PRODUCTS: Pennco - Hotline Series Indirect Water Heater

Subject: Coil Change

Models Effected: HL-30, 40, 50, 80 & 119

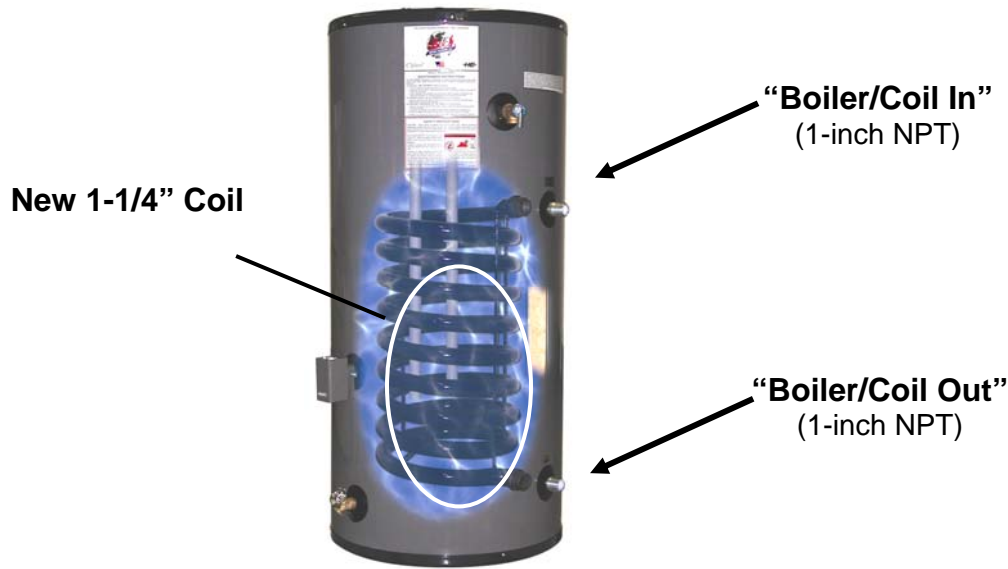
Effective immediately the Hotline Series Indirect Hot Water Heaters have changed as follows: (see illustration below)

- HL30, HL40 & HL50 have relocated their "boiler/coil in" and "boiler/coil out" tapings. Previously on the top, these connections are now on the side of the tank.
- All Hotline sizes (HL30 - HL119): Internal coil diameters have increased from 3/4" to 1-1/4". Coil connections for all sizes will now be 1-inch NPT.

NOTE: The change in the coil does not effect the location or size of the domestic Hot and Cold connections.
